International Forest Products Ltd. FLA19220
 Stuart Island Pre-harvest and Post-harvest Visual Assessment Comparison
 RDI Resource Design Inc - September 28, 2013

RDI Resource Design Inc Peer Review September 26, 2011

RDI was requested to provide a peer review of the VIA, including viewpoint selection and weighting, the landform approach, visual force analysis, block design and percent alteration. These were all contained in the Interfor VIA dated September 26, 2011.

MOF3 RDI FREP Analysis - 5.32% alteration

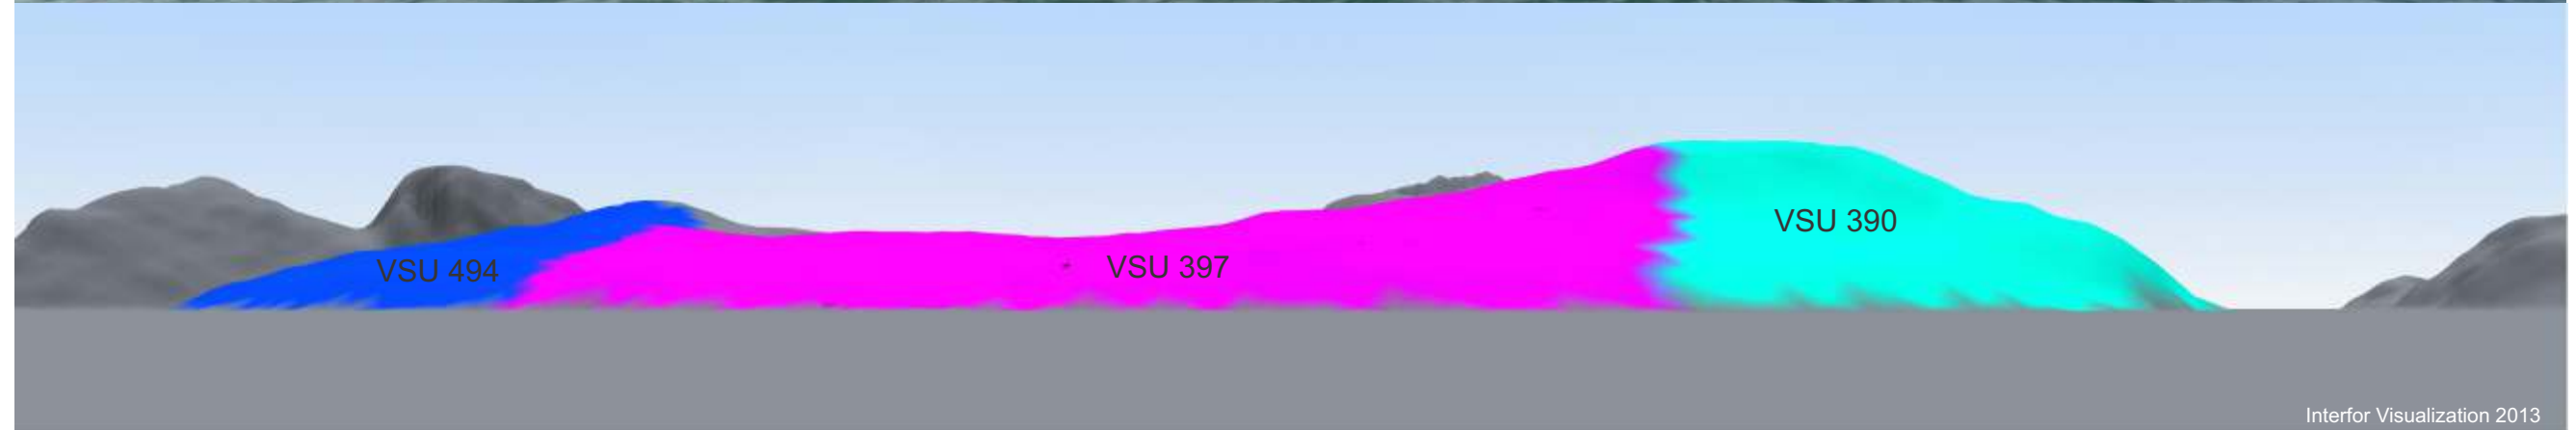
RDI FREP Visual Quality Effectiveness Evaluation Viewpoint MOF3

2.2.3 Assess Basic VQC (RDI office)				
Basic VQC	PR			
2.2.4 Design Observations (RDI office)				
Design Elements	G (-1)	M (0)	P (+1)	
Response to Visual Force Lines	-1			
Borrows from natural character	-1			
Edge treatments incorporated	-1			
Distance from Viewpoint		0		
Position on Landform**			1	
Total Design	-2

2.3.4 Partial Cut Alterations				
	n/a			
2.3.5 Effectiveness Evaluation Rating				
	PR Met (methods indicate VQO achievement but are close to the high end "maximum percent alteration limit" of 7%.

**Note: Harvesting is in centre vertically, and at one end of landform which warrants a somewhat more positive rating in 2.2.4, and would bring the adjusted % alteration further under 7%. The current definitions in the FREP form do not offer one that is "central vertically on the landform and towards one side".

JB1 RDI FREP Analysis - 6.82% alteration

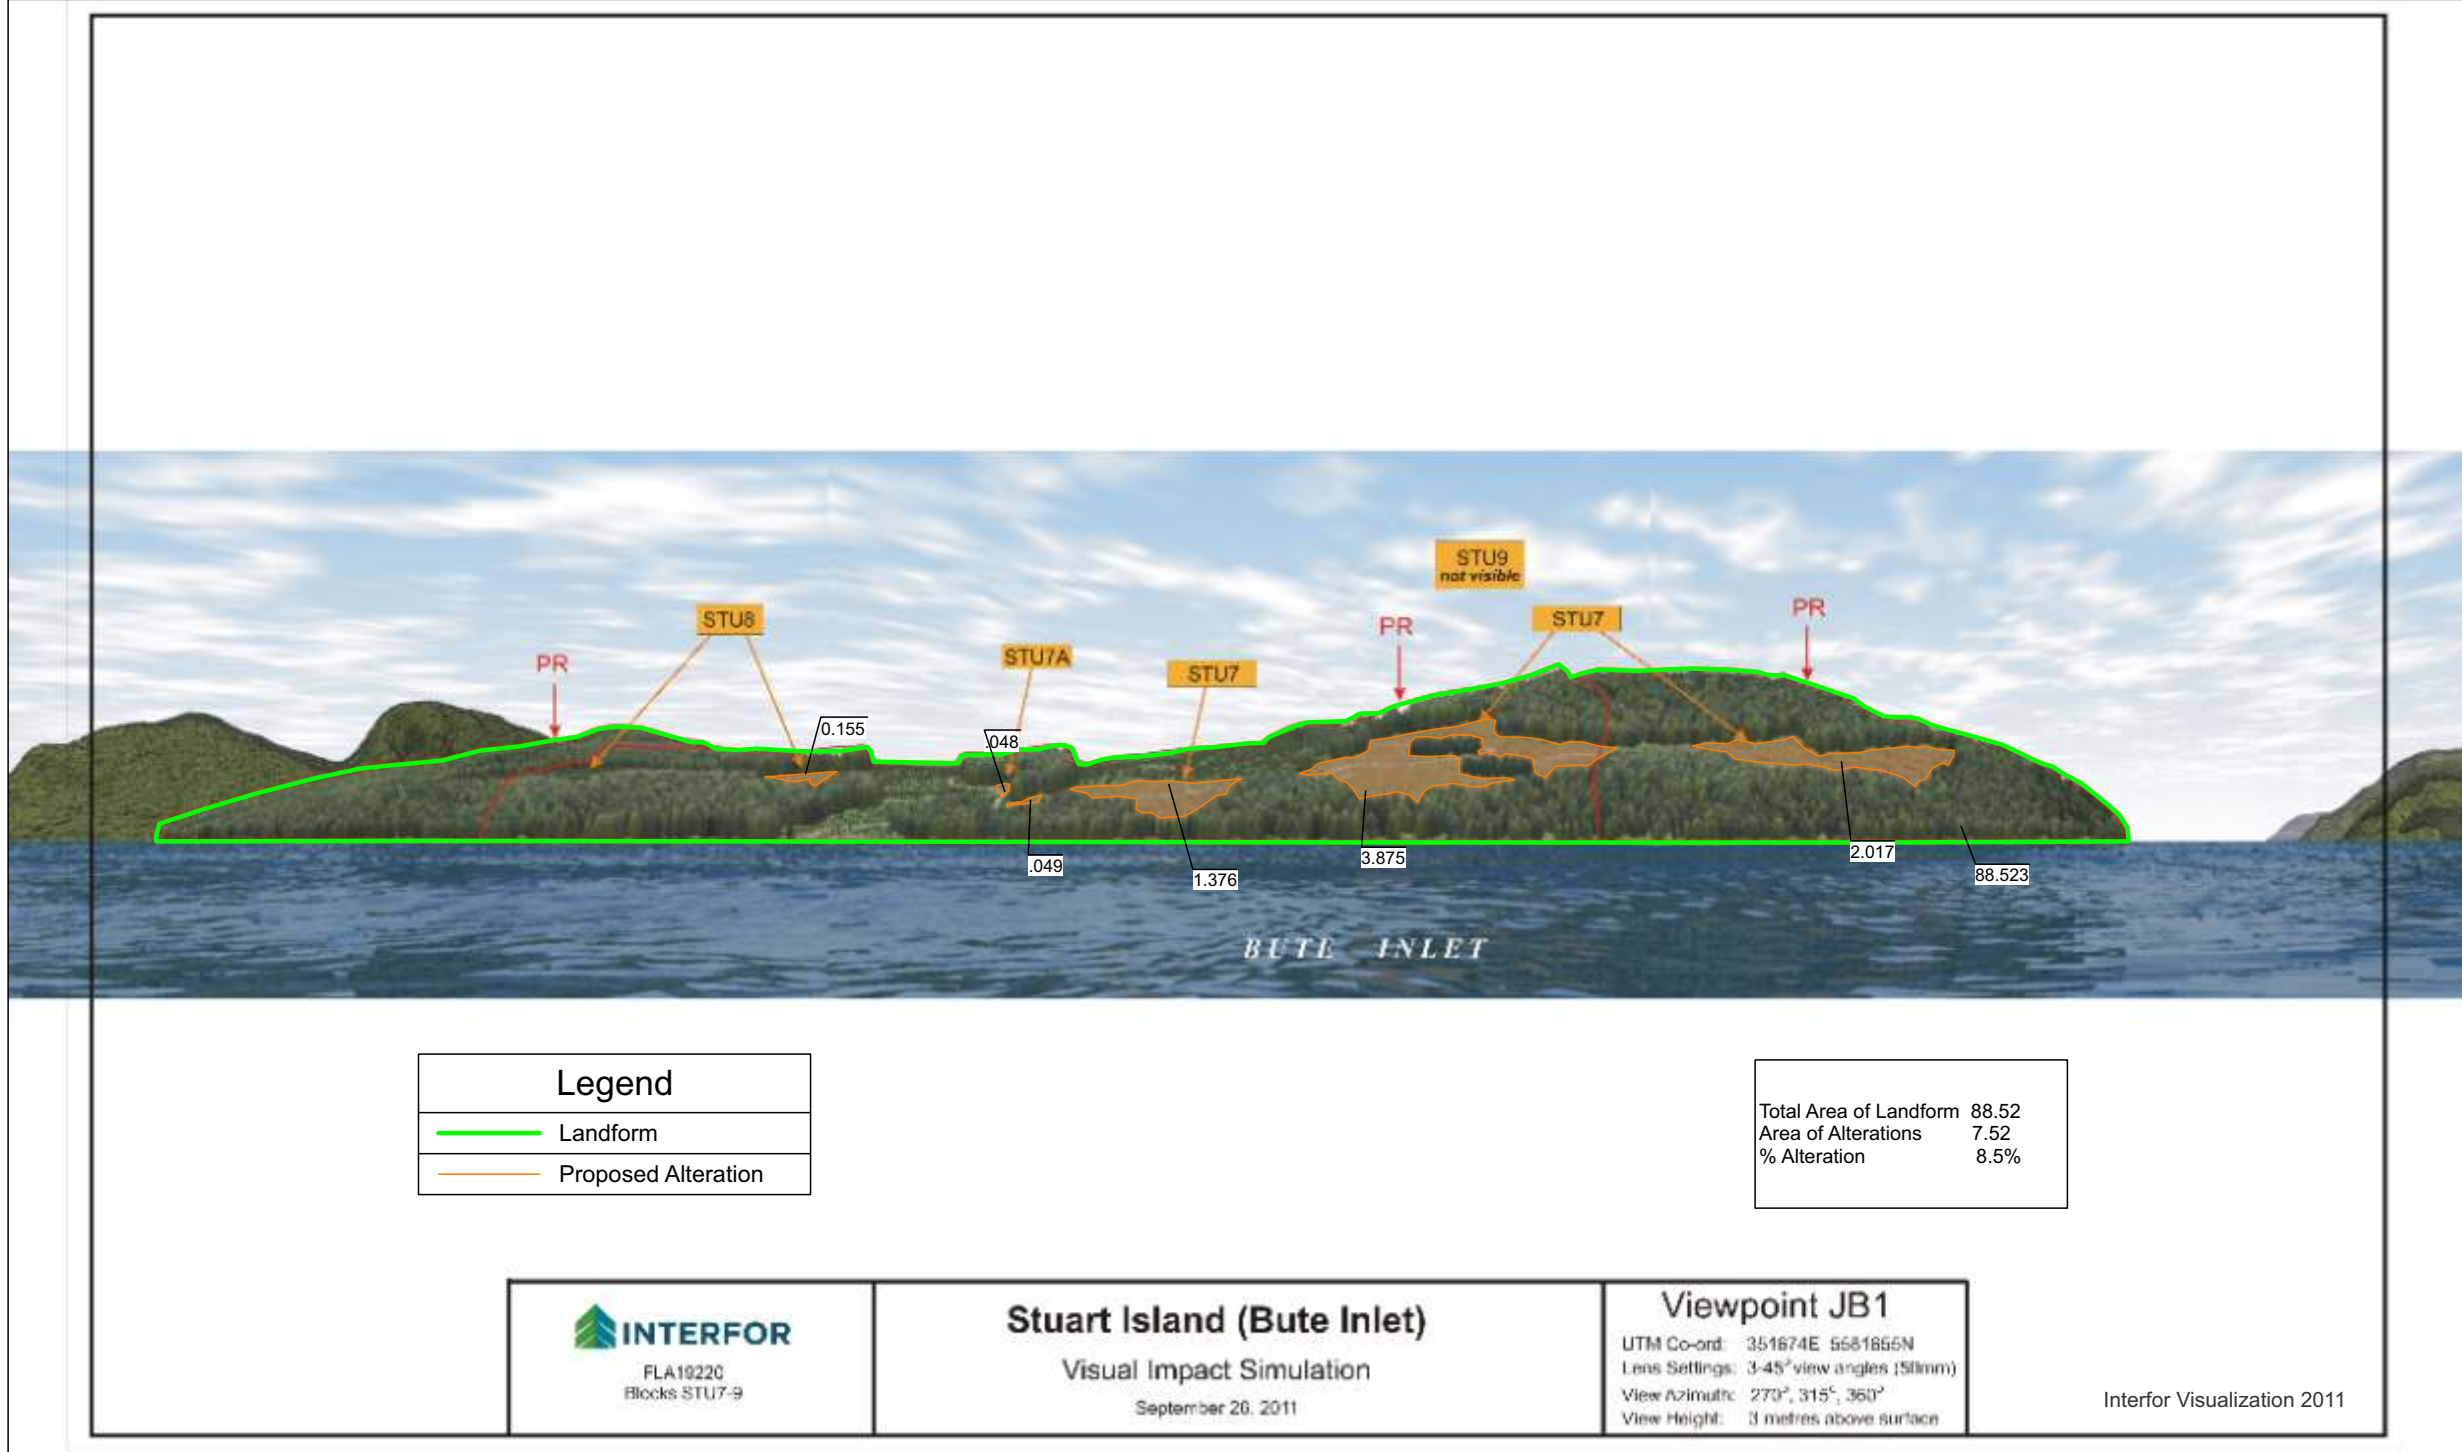
RDI FREP Visual Quality Effectiveness Evaluation Viewpoint JB1

2.2.3 Assess Basic VQC (RDI office)				
Basic VQC	PR			
2.2.4 Design Observations (RDI office)				
Design Elements	G (-1)	M (0)	P (+1)	
Response to Visual Force Lines	-1			
Borrows from natural character	-1			
Edge treatments incorporated	-1			
Distance from Viewpoint		0		
Position on Landform**			1	
Total Design	-2

2.3.4 Partial Cut Alterations				
	n/a			
2.3.5 Effectiveness Evaluation Rating				
	PR Met (methods indicate VQO achievement but are close to the high end "maximum percent alteration limit" of 7%.

**Note: Harvesting is in centre vertically, and at one end of landform which warrants a somewhat more positive rating in 2.2.4, and would bring the adjusted % alteration further under 7%. The current definitions in the FREP form do not offer one that is "central vertically on the landform and towards one side".

Early IFP Scenario 5 from VP JB1 not implemented due windthrow potential and operational constraints.

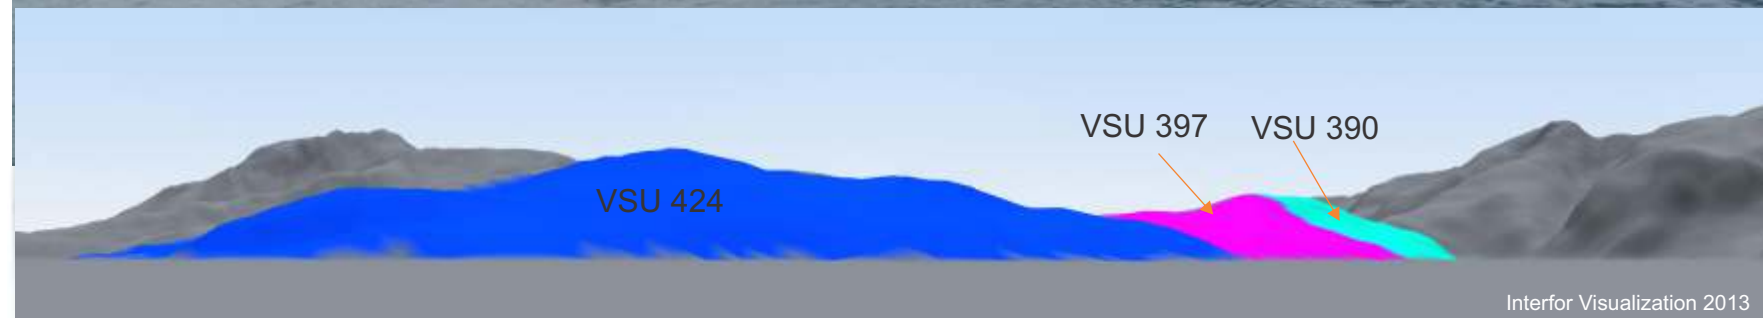
Block design scenarios, percent alteration calculations and visual force analyses were provided to RDI by Interfor in high-caliber visual simulations from 3 viewpoints: JB1, JB3, CH1. These were commented upon by RDI, with our encouragement to reduce size of openings similar to one of the options (Scenario 5, shown on the final page of this document). Windthrow potential and operational requirements

JB3 RDI FREP Analysis - 1.89% alteration

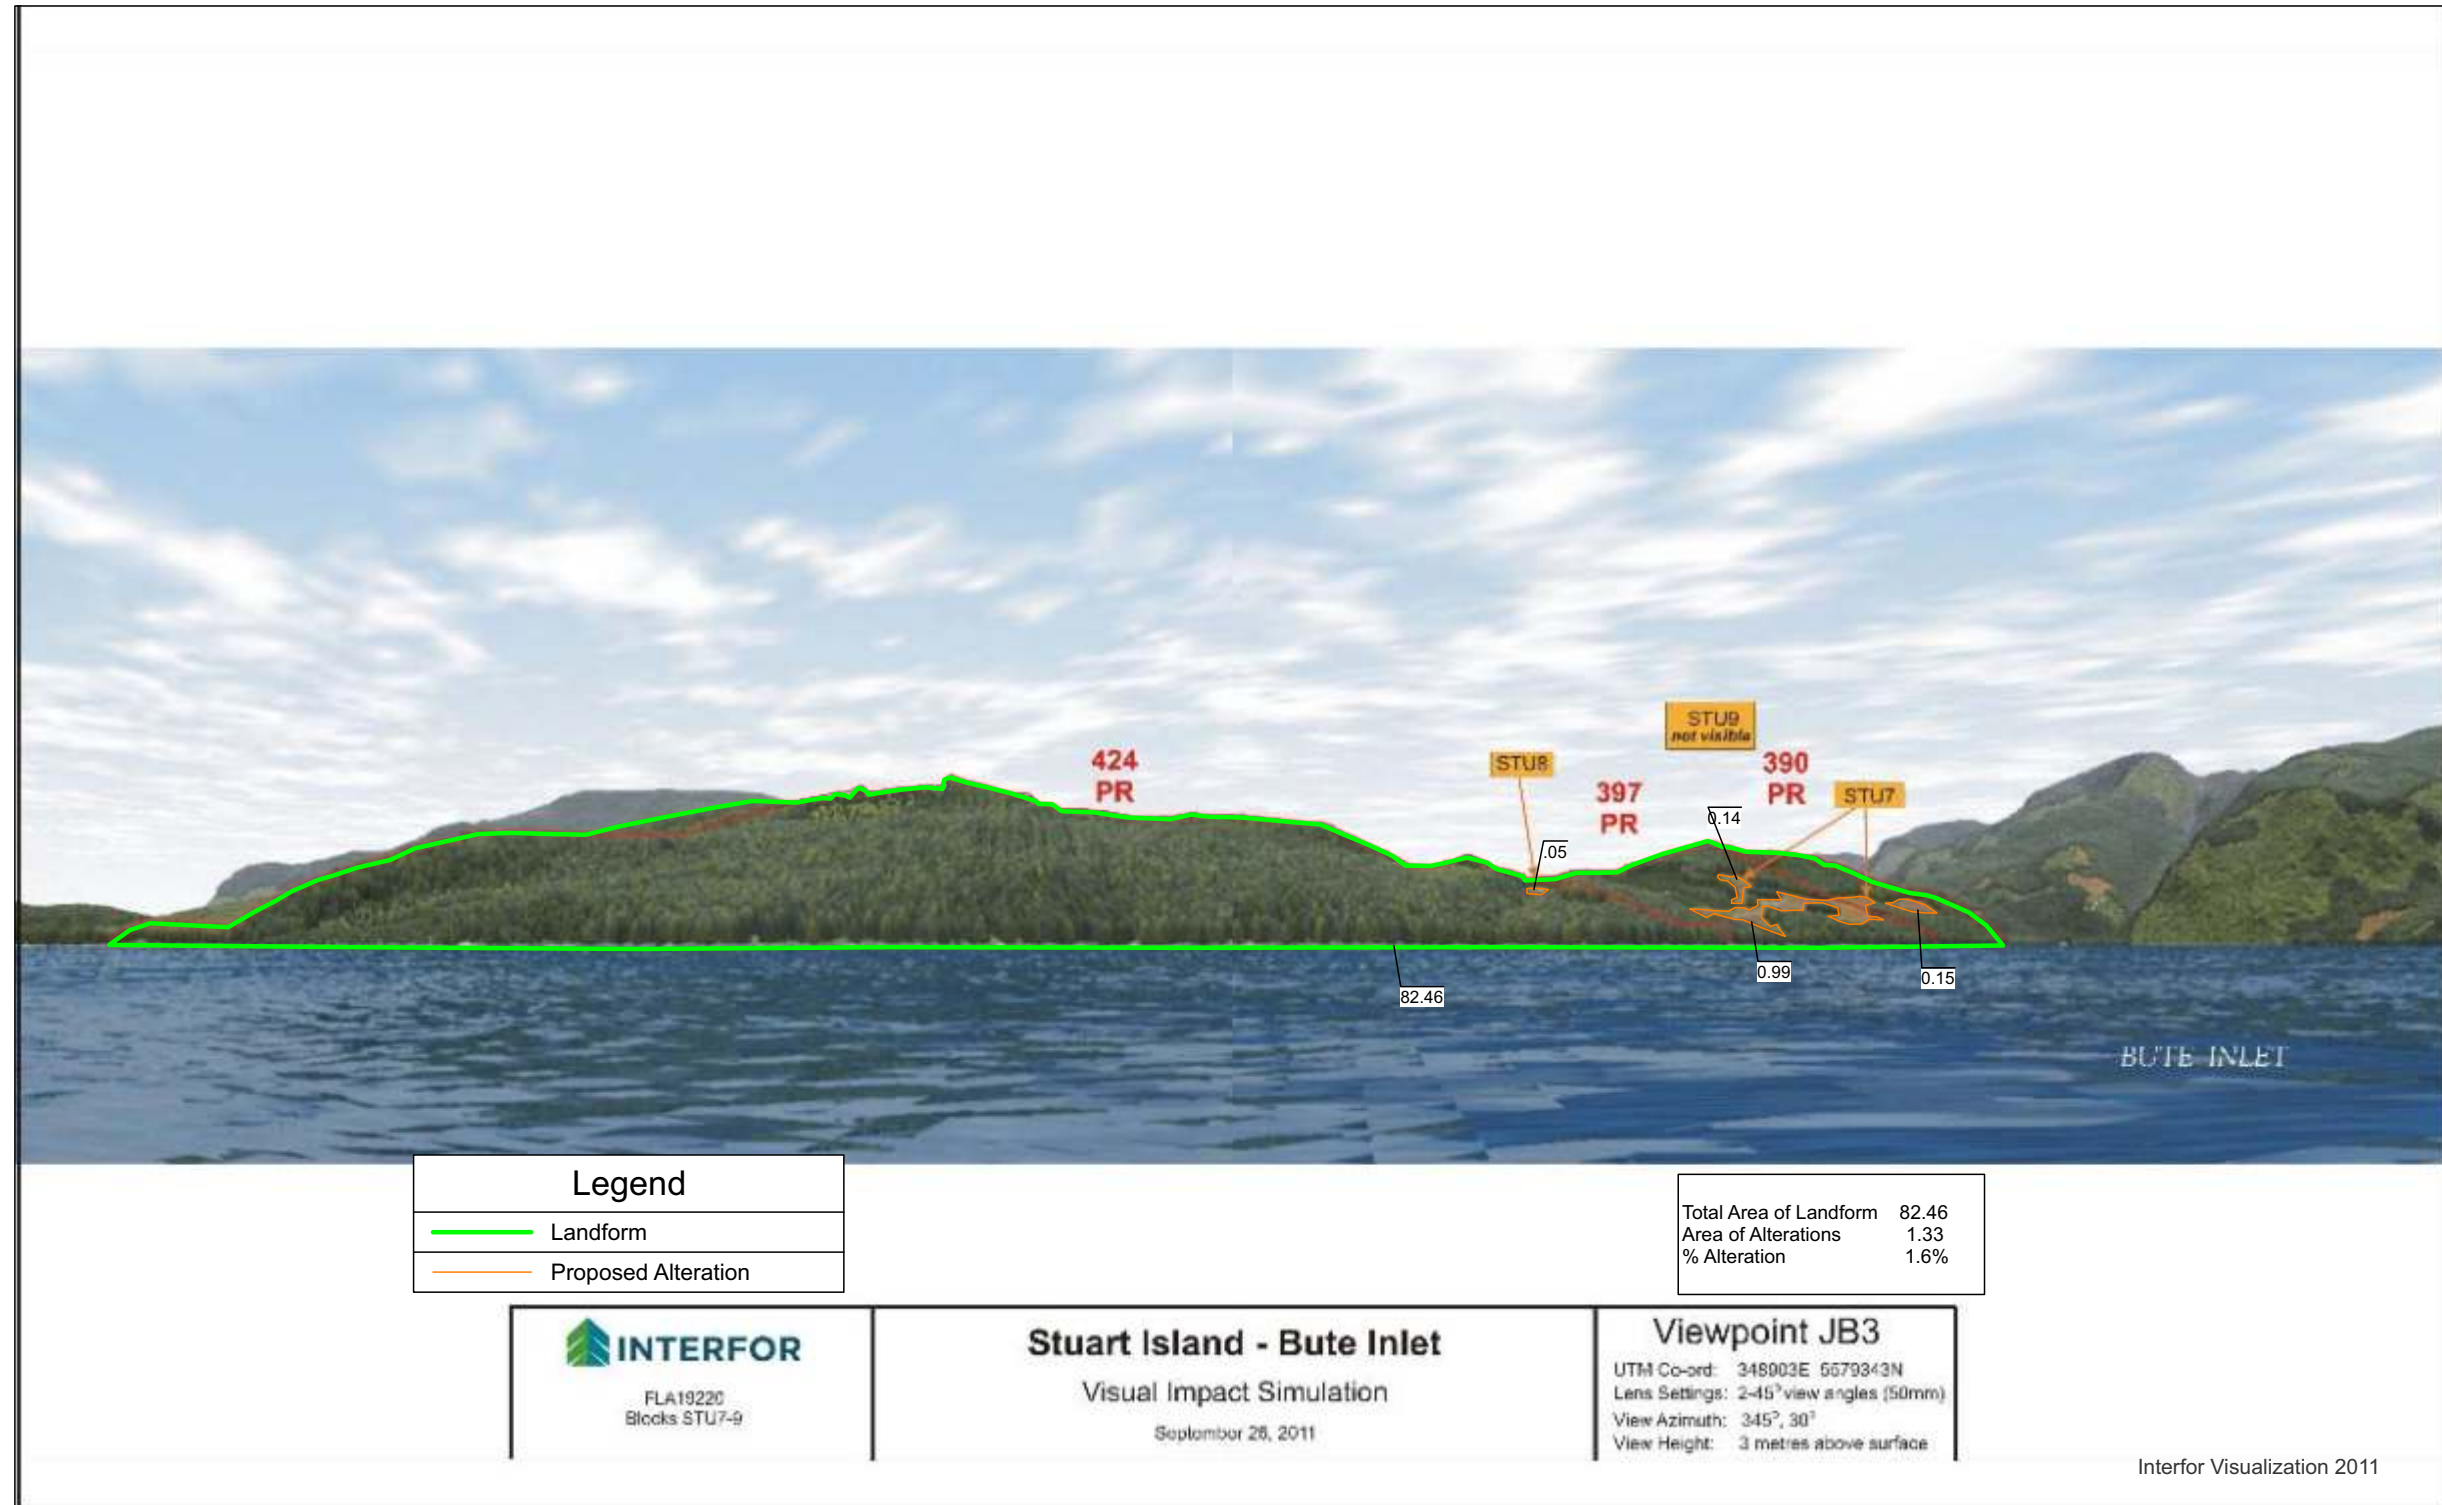
RDI FREP Visual Quality Effectiveness Evaluation Viewpoint JB3

2.2.3 Assess Basic VQC (RDI office)				
Basic VQC	PR			
2.2.4 Design Observations (RDI office)				
Design Elements	G (-1)	M (0)	P (+1)	
Response to Visual Force Lines	-1			
Borrows from natural character	-1			
Edge treatments incorporated	-1			
Distance from Viewpoint		0		
Position on Landform**			1	
Total Design	-2

2.3.4 Partial Cut Alterations				
	n/a			
2.3.5 Effectiveness Evaluation Rating				
	PR well met (methods indicate VQO achievement and are on the lower % alteration limit or mid-range for the class.

**Note: Harvesting is in centre vertically, and at one end of landform which warrants a somewhat more positive rating in 2.2.4, and would bring the adjusted % alteration further under 7%. The current definitions in the FREP form do not offer one that is "central vertically on the landform and towards one side".
